STATE OF HAWAII
DEPARTMENT OF TRANSPORTATION
HIGHWAYS DIVISION

ADDENDUM NO. 2

**INTERSTATE ROUTE H-1 ADDITION AND MODIFICATION OF FREEWAY ACCESS
(KAPOLEI INTERCHANGE COMPLEX), PHASE 3**

FEDERAL-AID PROJECT NO. NH-H1-1(271)

FED. ROAD DIST. NO.	STATE	FED. AID PROJ. NO.	FISCAL YEAR	SHEET NO.	TOTAL SHEETS
HAWAII	HAW.	NH-HI-K(271)	2022	ADD. 53	167

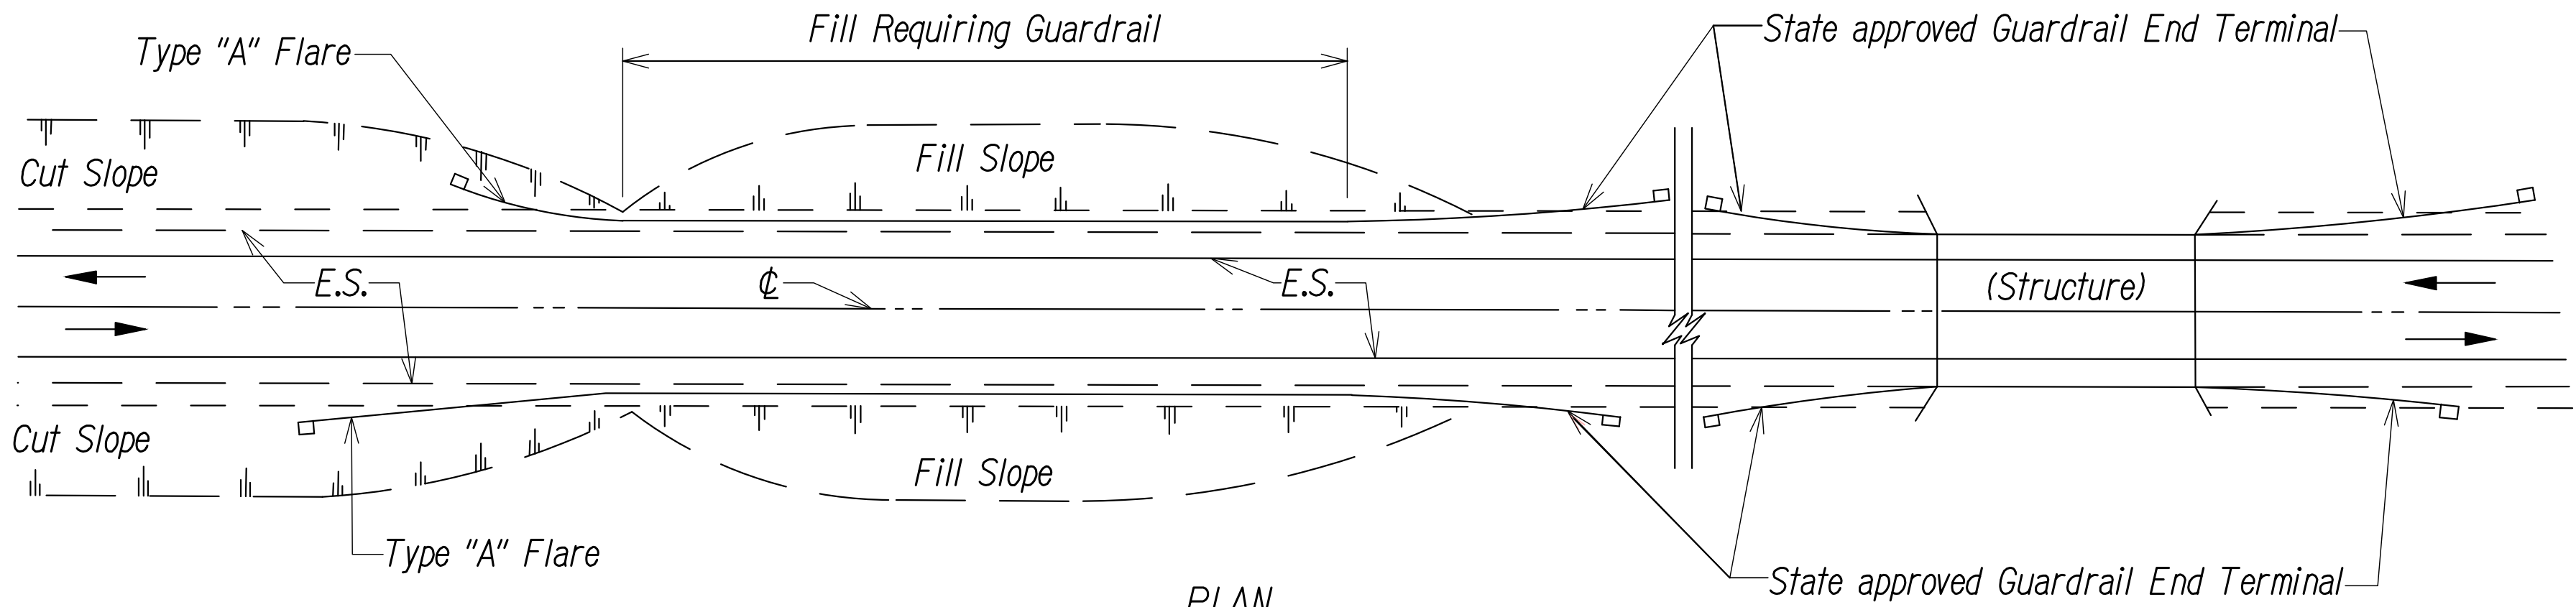
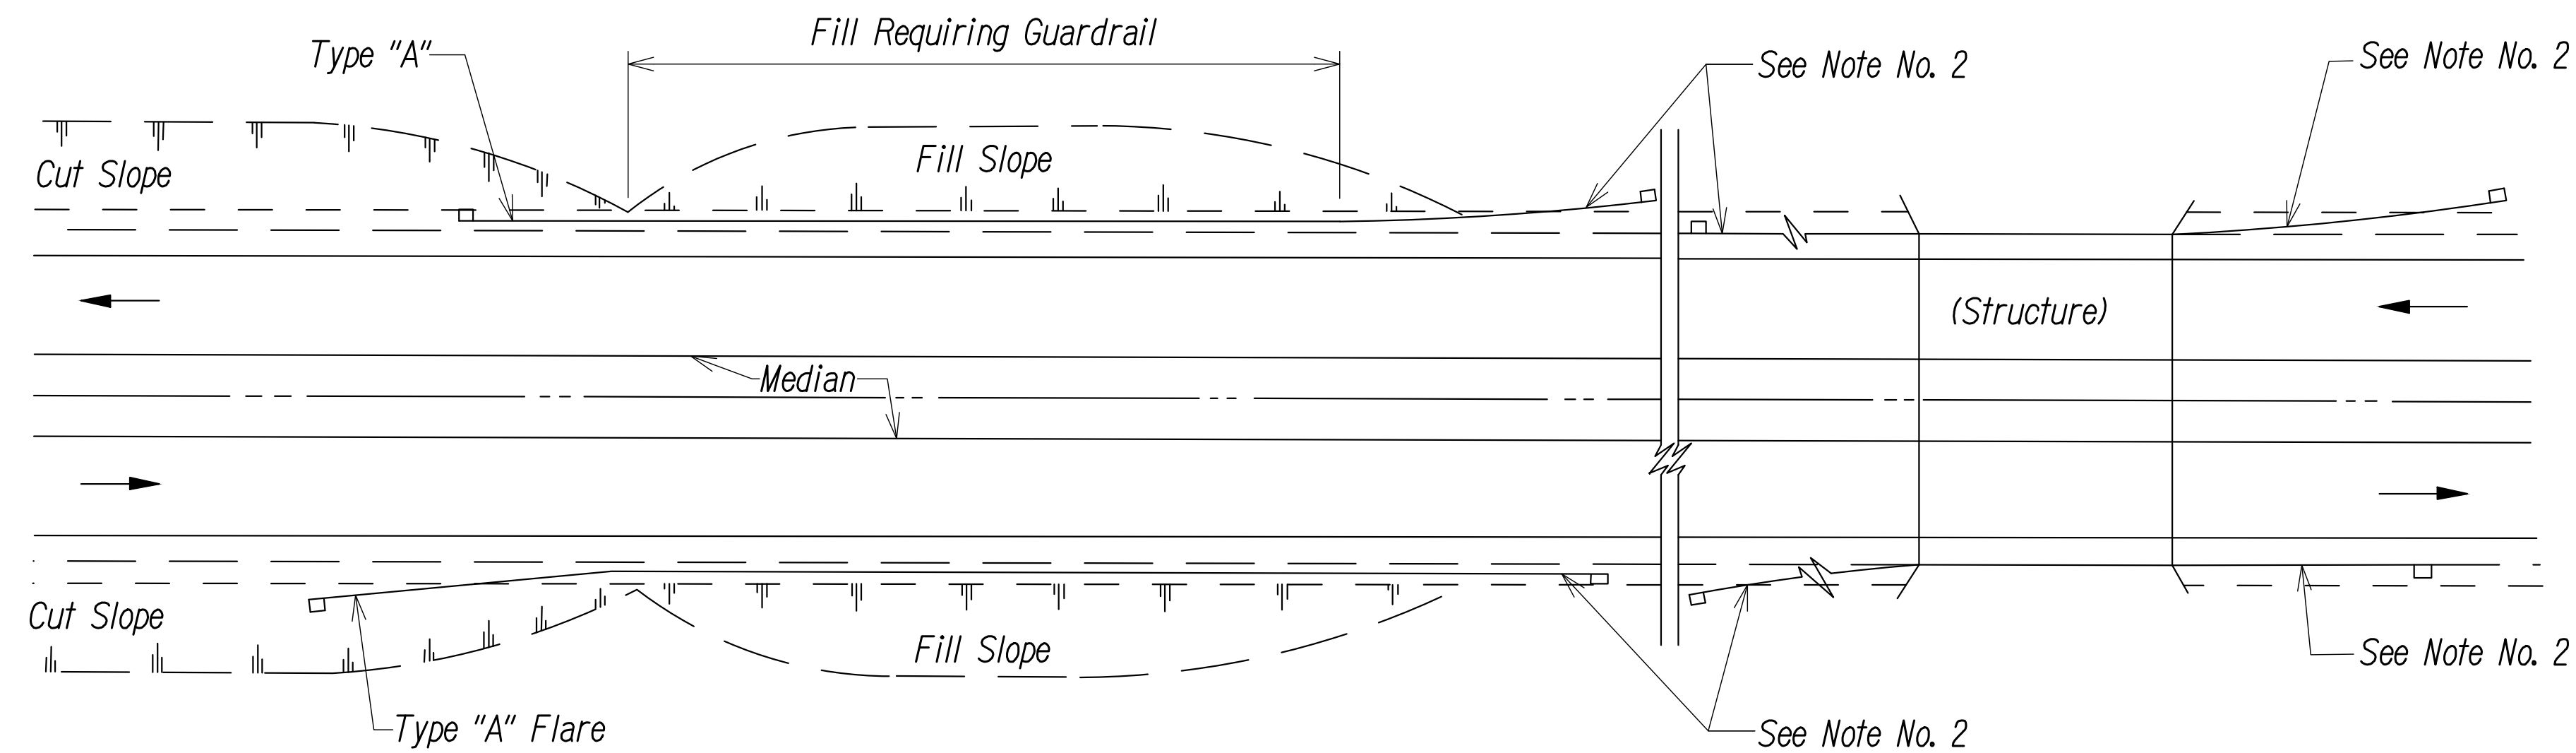
10/21/2022	Revised note 3 to MASH
DATE	REVISION
STATE OF HAWAII DEPARTMENT OF TRANSPORTATION HIGHWAYS DIVISION	
GUARDRAIL DETAILS 1	
INTERSTATE ROUTE H-1 ADDITION AND MODIFICATION OF FREEWAY ACCESS (Kapolei Interchange Complex), Phase 3 Federal Aid Project No. NH-HI-K(271)	
Scale: As Noted	Date: August 2022

4. on sheet 53 Note 3 calls out NCHRP-350 approved Guardrail End Terminals, but the pay items call out MASH approved End Terminals, can you please clarify?

Revised to MASH. See revised sheet 53 in Addendum No. 2.

Light Standard Base Section on Retaining Wall
Scale: 1'=1'-0"

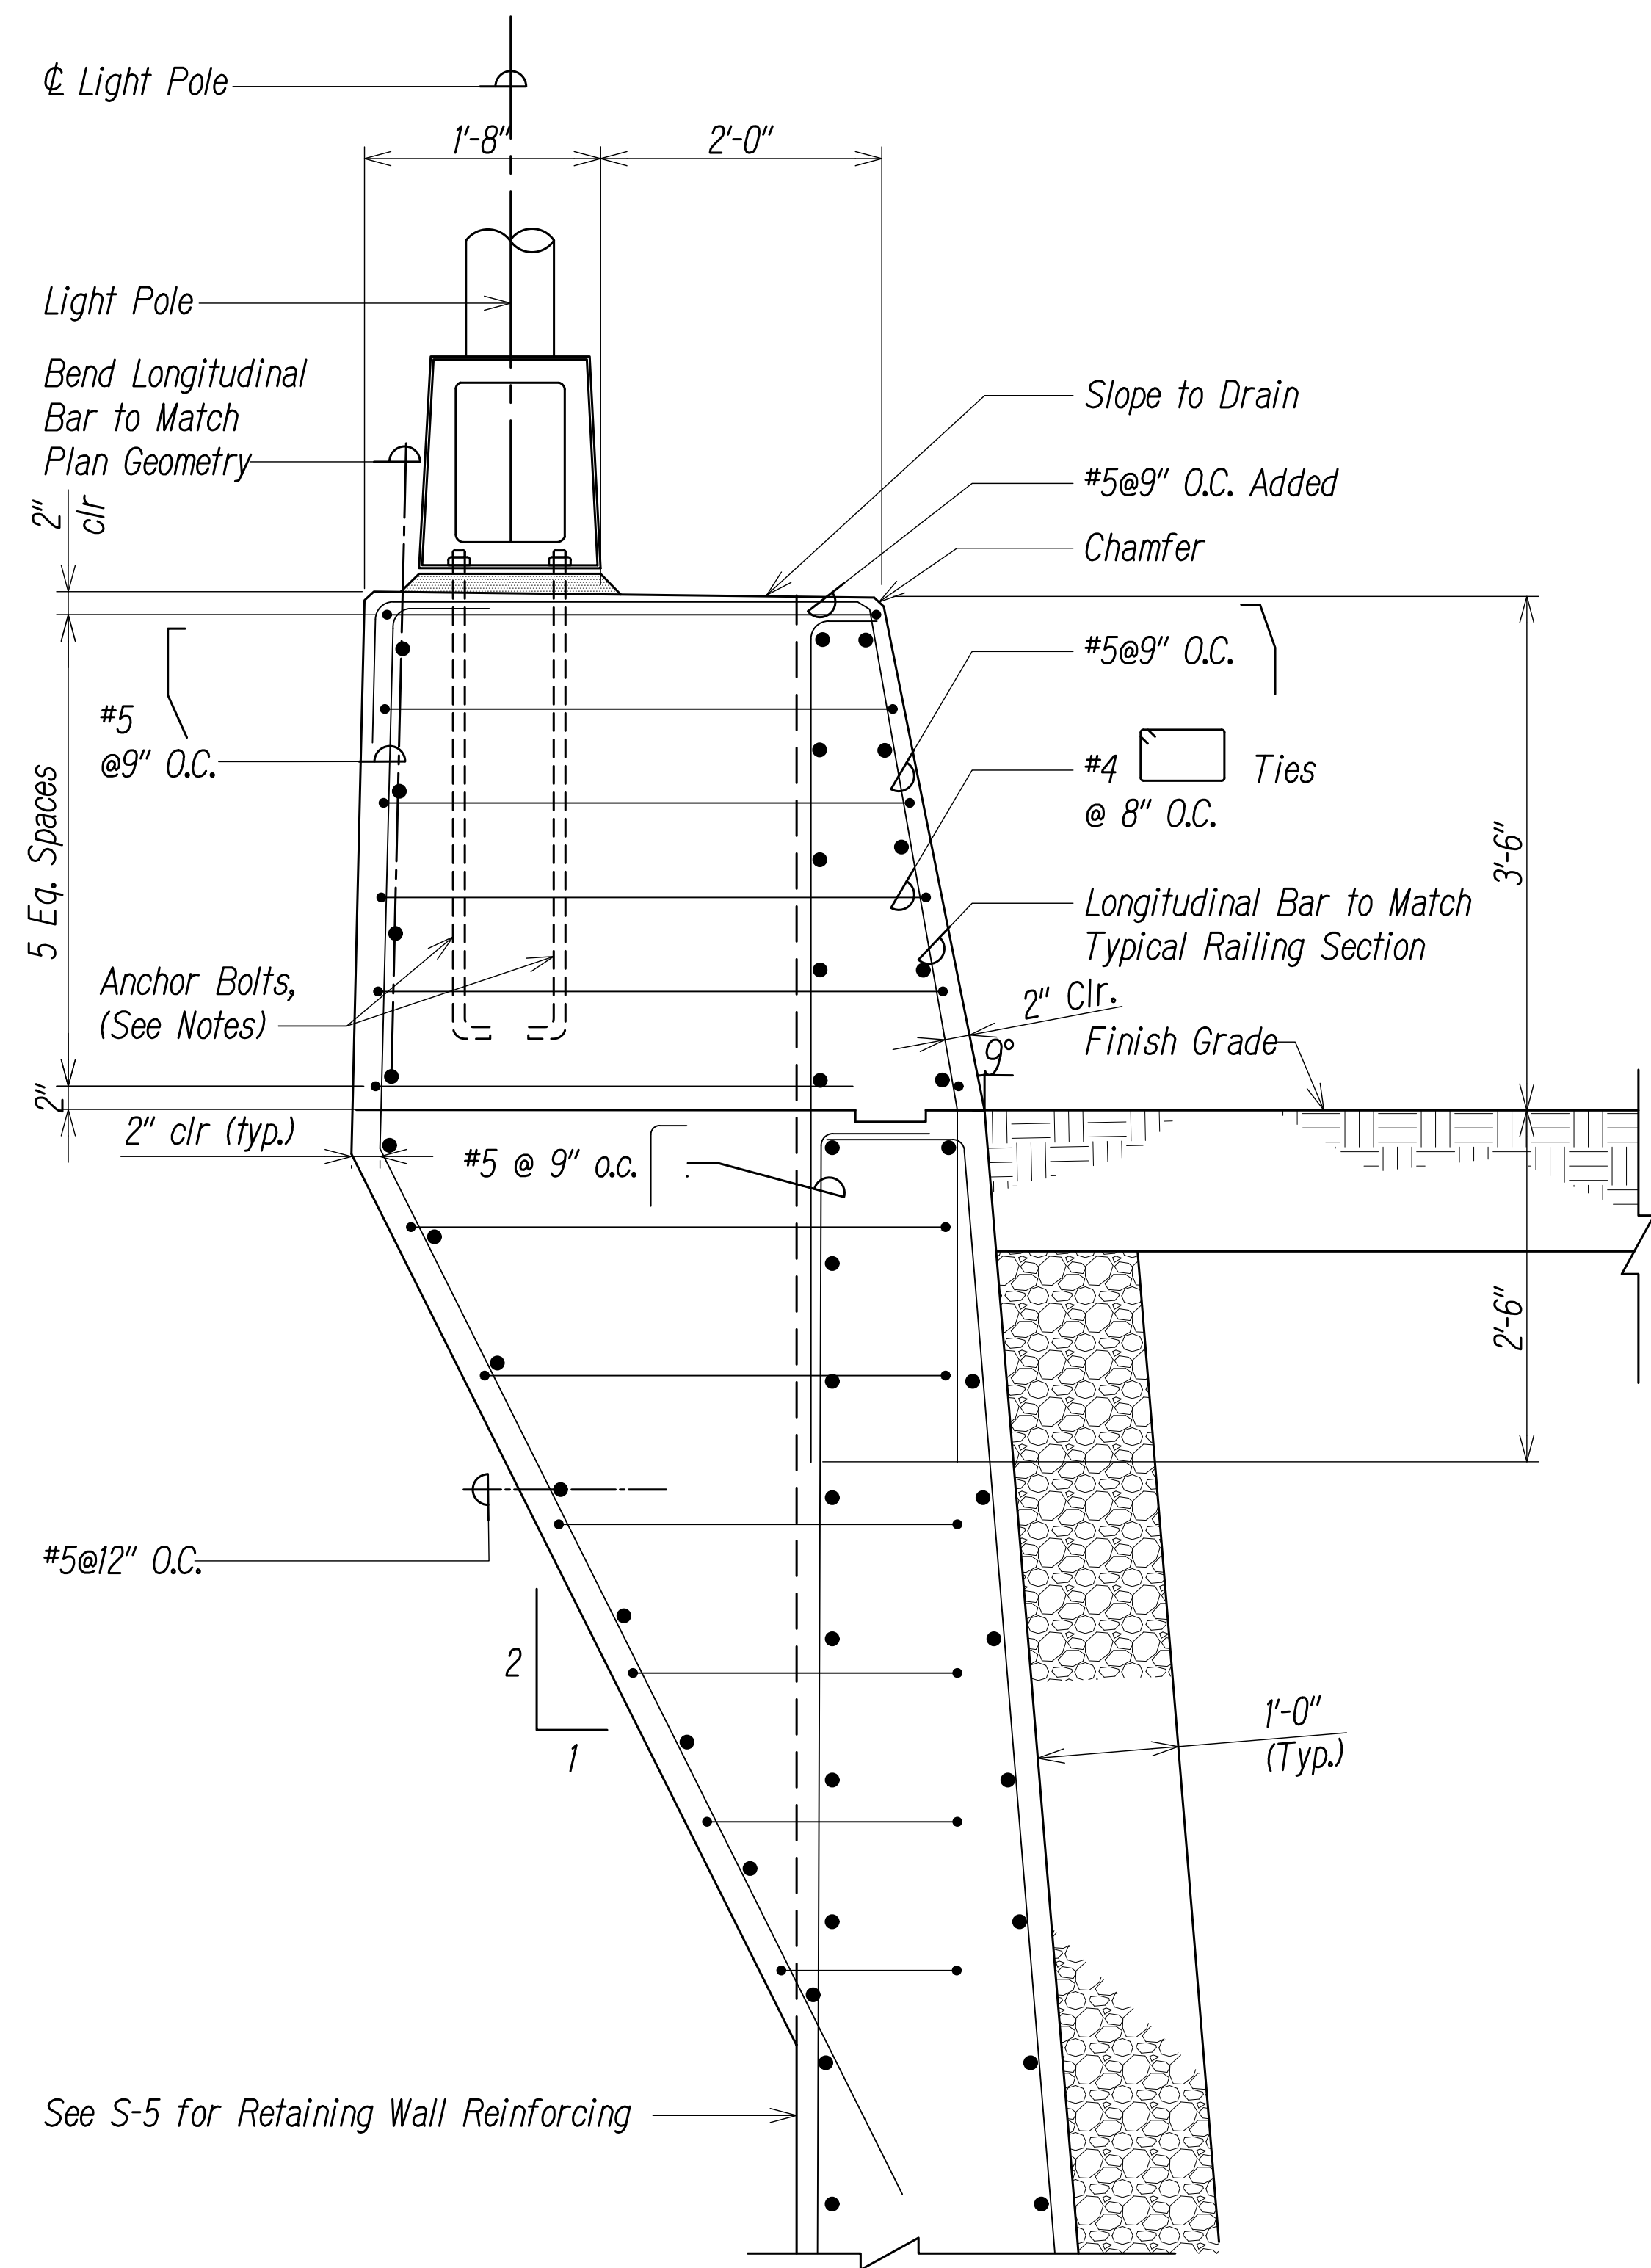
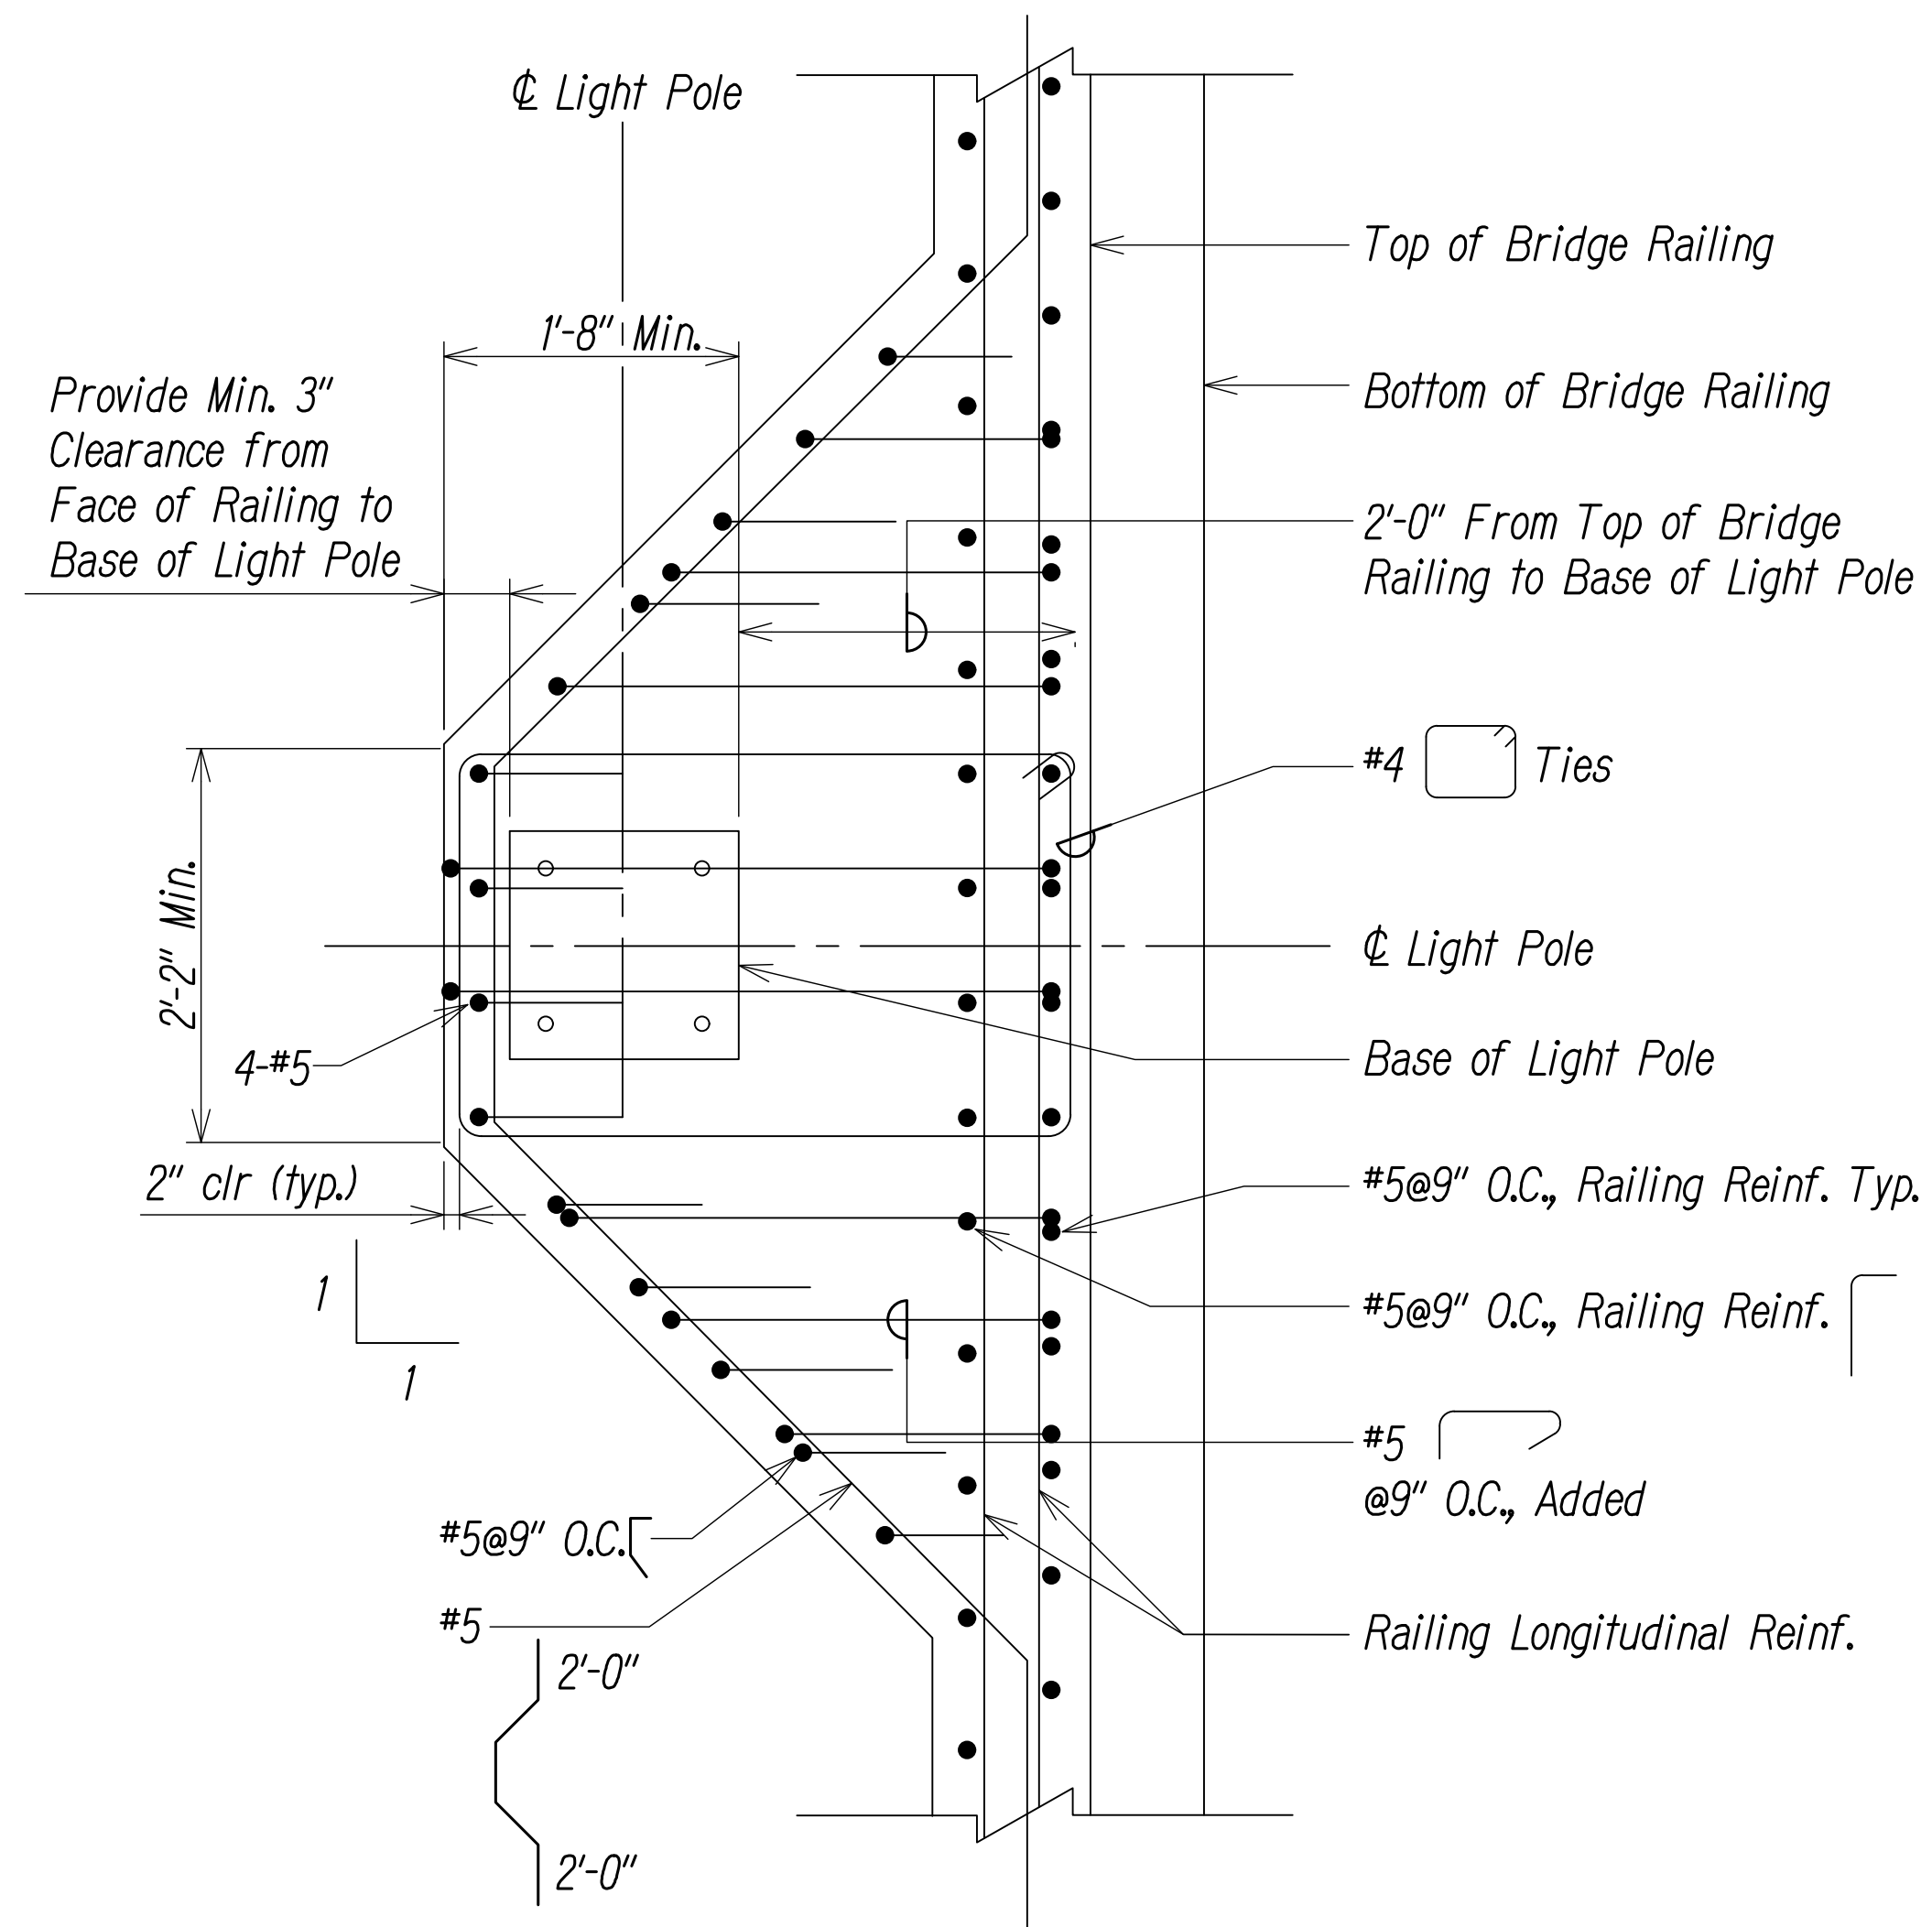
19. Sheet S-7 shows a light base detail. Please provide locations where this is required.

Added callout pointing to locations of light base locations on sheet S-3 Overall Retaining Wall Plan. See Addendum No. 2.
